MEMORANDUM

SUBJECT: **Second Agenda Packet Memo** - Consideration of Wireless Communication Facilities Permit Application, filed by Gulf South Towers Capital Partners LLC and Rick Hirsch, for 898 Red Rock Road

Review of GST Monopole Application

**Prepared for the City of Piedmont, California
March 1, 2021**

Figure 2: Monopole Antenna Mounting

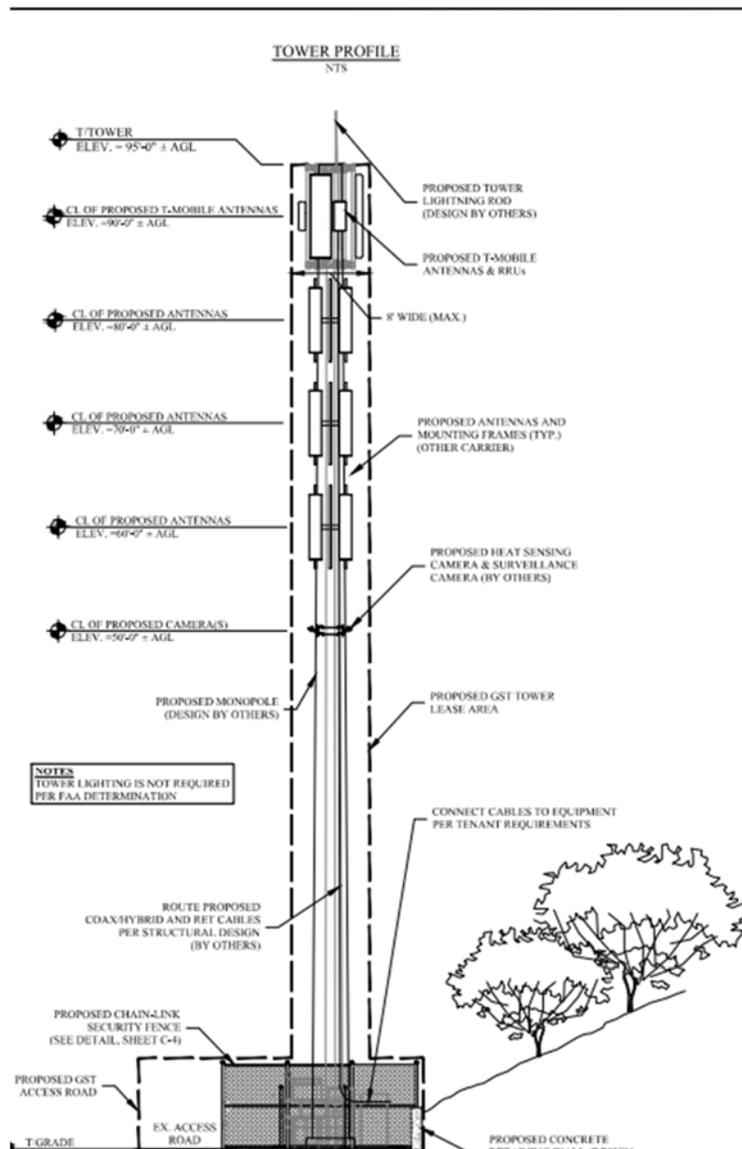
Figure 2 is an engineering drawing submitted by GST illustrating the mounting of the wireless panel antennas. In order to minimize visual clutter, there are no traditional antenna cross arms or platforms at 10' intervals for panel mounting. Instead, the panels will be mounted close to the monopole with the associated cabling contained within the monopole. This will reduce the visual capture area, making the structure less prominent. However, with this design, there are trade-offs using the direct pole mounting, since it reduces the number of antennas and the bearing sitings that can be accommodated. Since the tower is less than 200 feet tall and not in the area of an airport glide path, there is no requirement to have lighting on the tower.

Figure 3: Google Earth Photo of Site with 150-Foot Circle

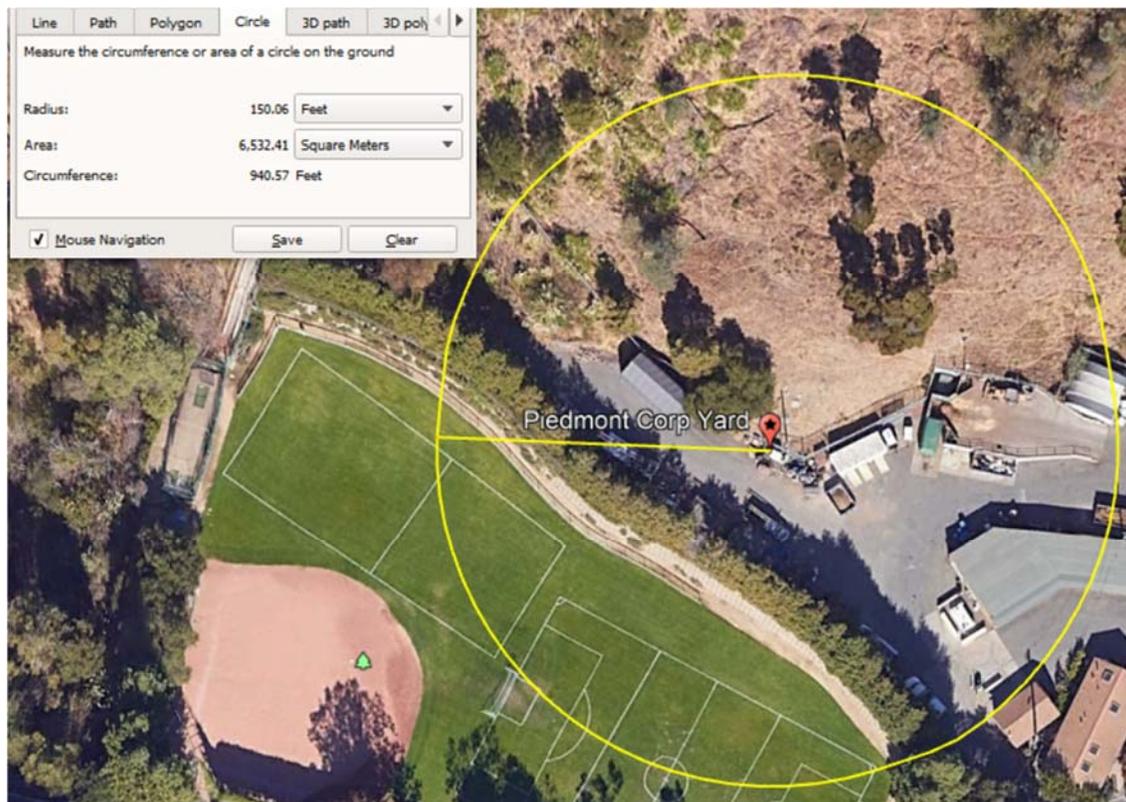
Figure 3: Google Earth Photo of Site with 150-Foot Circle (below) is a Google Earth photo illustrating that there are no multi-story structures (i.e., locations at the same height as the T-Mobile antennas) within 150 feet of the site where an individual might be exposed to radiation that exceeds the FCC's public exposure guidelines.

Figure 4: Typical 65° Beamwidth Radiation Pattern for Applicant's Proposed Low-Band Antenna Panel⁵

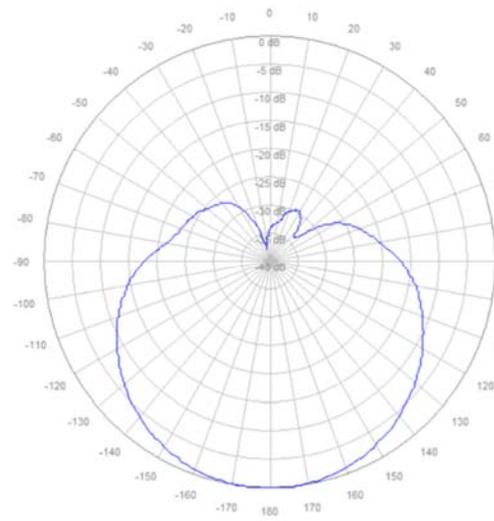
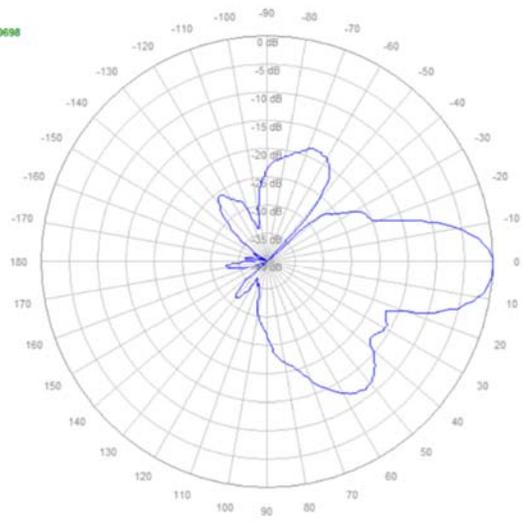
- Figure 4: Typical 65° Beamwidth Radiation Pattern for Applicant's Proposed Low-Band Antenna Panel (below) is the typical horizontal and vertical radiation pattern for the proposed T-Mobile antennas.
- If three other wireless carriers (i.e., for a total of four carriers) were to install current-generation antennas and remote radio transmission equipment similar to the proposed T-Mobile equipment on this proposed monopole, the maximum aggregate ERP of the four carriers' facilities would be 104 kW.⁴ This assumes the antennas would be mounted at regular vertical intervals and that each of the antennas' beam sectors were centered at 150°, 230°, and 290°.

Figure 5: Low-Band Coverage for In-Building Service

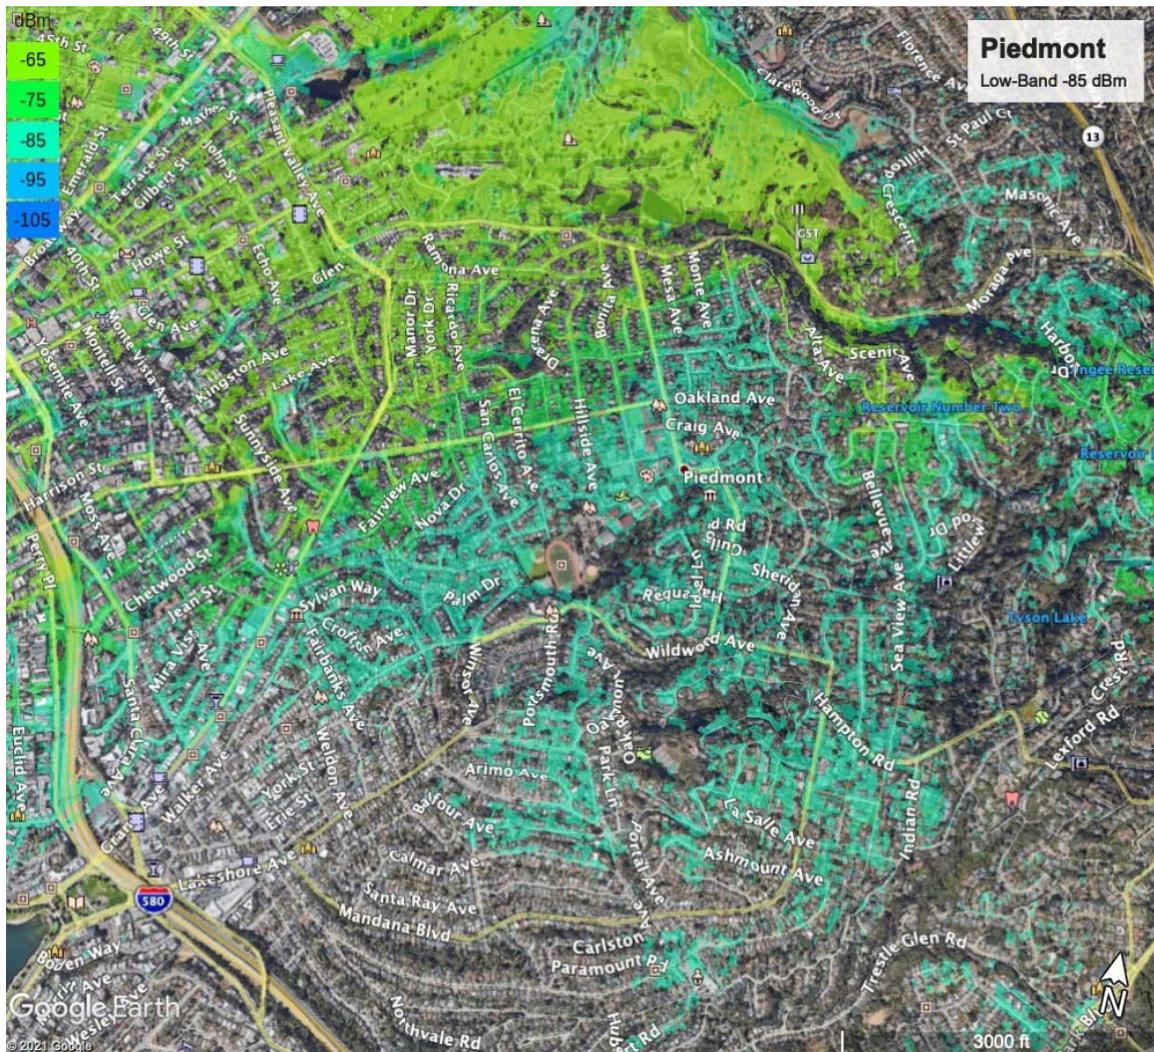
The following maps provide estimated coverage from the site for antenna mounted at the top level (90' radiation center). Coverage maps have been calculated for the low-band (600-850 MHz) and mid-band (1900 – 2500 MHz) wireless spectrum. Plots for citywide and expanded Moraga Ave and Highway 13 coverage.⁶ While the models show the mid-band coverage is really only improved in the areas west and north of the proposed tower, the low-band coverage is improved throughout much of Piedmont, both in buildings (-85 dBm or greater) and in vehicles (-95 dBm or greater), as far east to the intersection of Moraga Avenue and Highway 13.

Figure 1: Google Earth Photo of Site with 150-Foot Circle

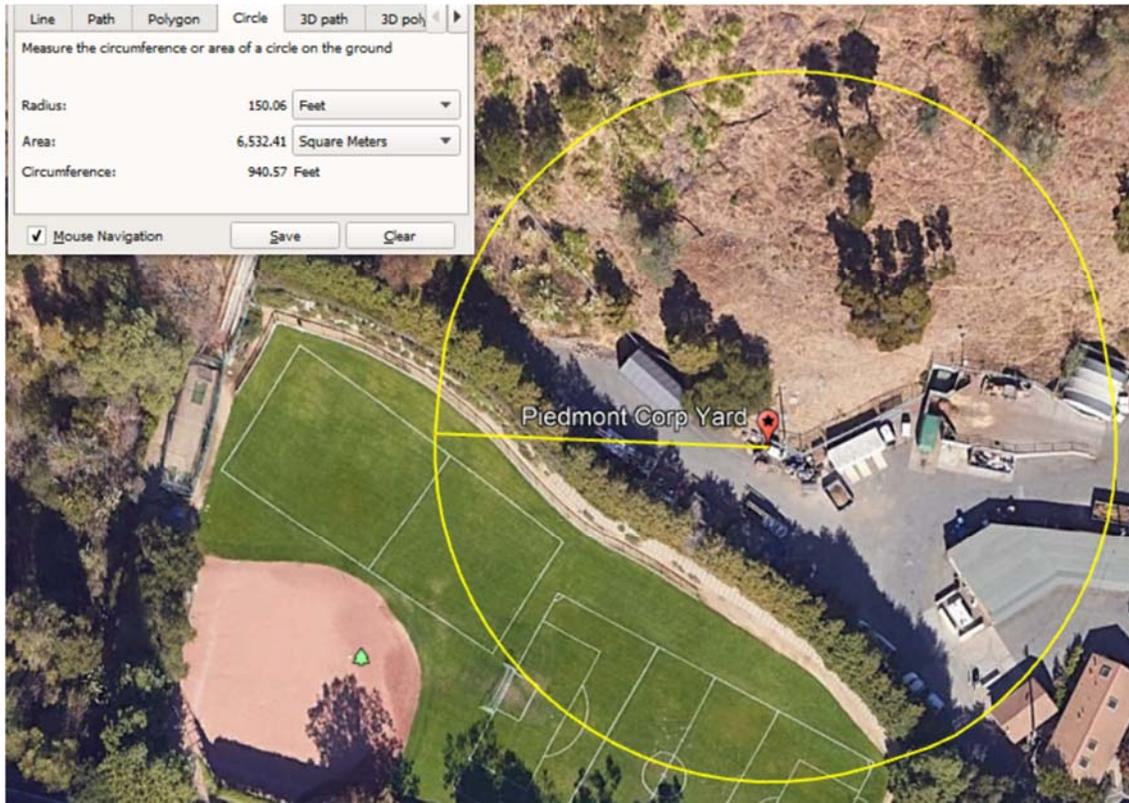
Figure 1 (below) is a Google Earth photo illustrating that there are no multi-story structures (i.e., locations at the same height as the T-Mobile antennas) within 150 feet of the site where an individual might be exposed to radiation that exceeds the FCC's public exposure guidelines.

Figure 2: Typical 65° Beamwidth Radiation Pattern for Applicant's Proposed Low-Band Antenna Panel⁴

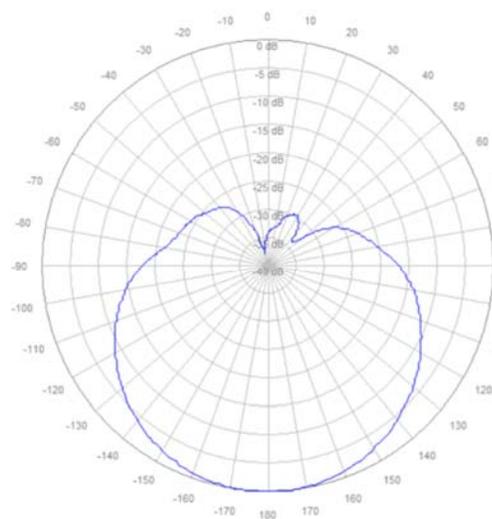
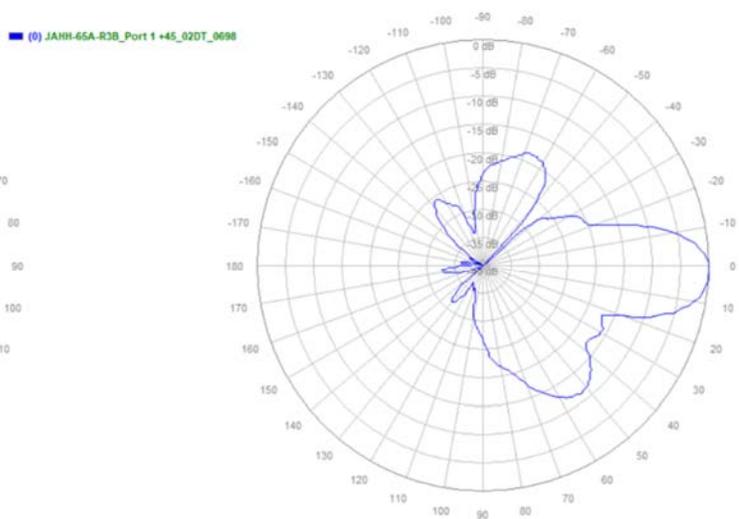
- The proposed T-Mobile antennas' vertical beamwidth pattern indicates that the signal power intensity is at least 13 dB (which equates to 1/20th of the linear power intensity) below the radiation in the horizontal plane. That is, the calculated downward radiation from the T-Mobile antennas mounted at 90 feet above ground level will not exceed 1.15 kW. Figure 2 (below) is the typical horizontal and vertical radiation pattern for the proposed T-Mobile antennas.

Figure 3: Enclosed Wireless Carrier Equipment Areas⁵

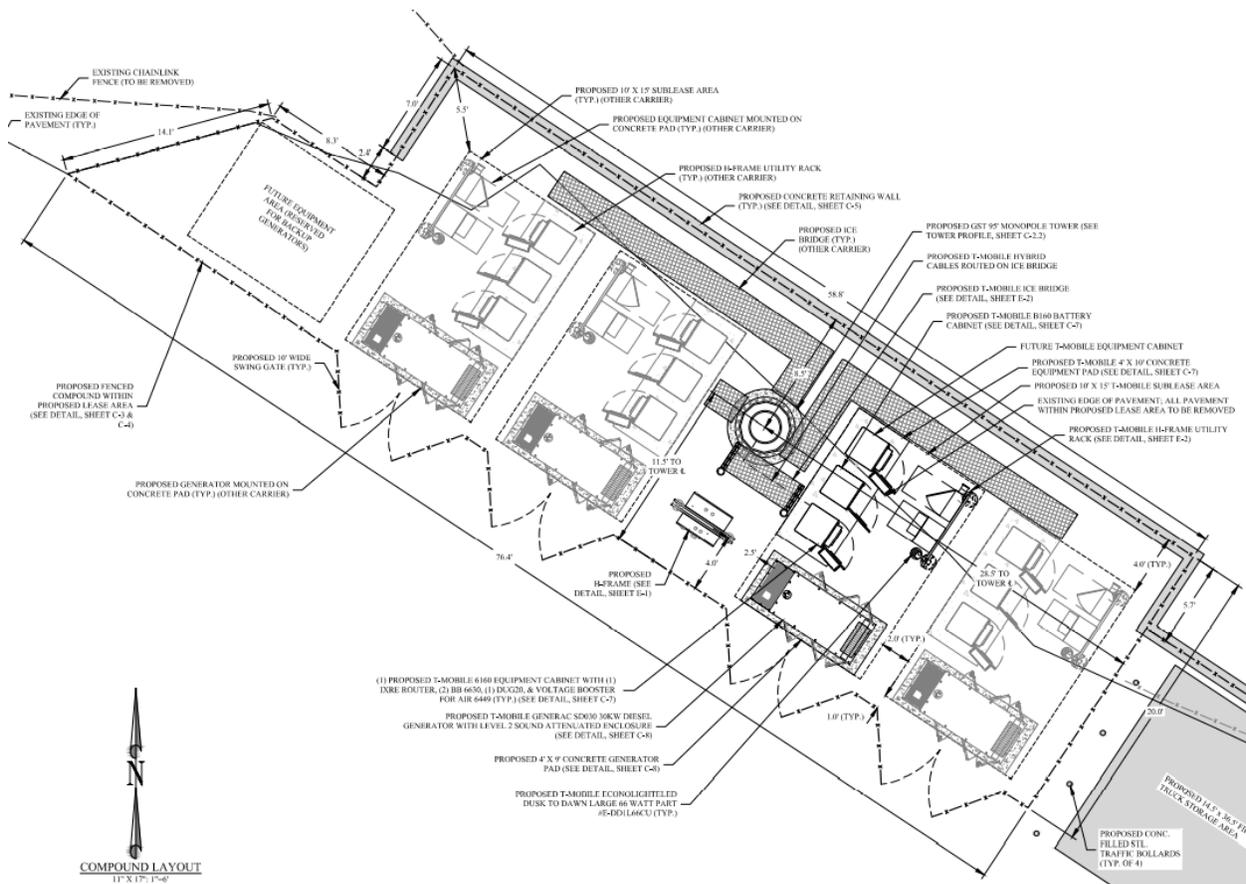
In terms of the feasibility of siting additional carriers' facilities on the proposed monopole in the future, we note the facility will include four secure fenced 10' x 15' enclosures to house the equipment of the wireless carriers that attach wireless facilities to the monopole (Figure 3). The enclosed equipment areas will each provide sufficient space to accommodate radio equipment, associated electronic devices, and a backup power generator.

According to the application, a cabling "ice" tray will be installed for routing coaxial cabling from the individual equipment enclosures to the monopole for connection to the antenna panels.
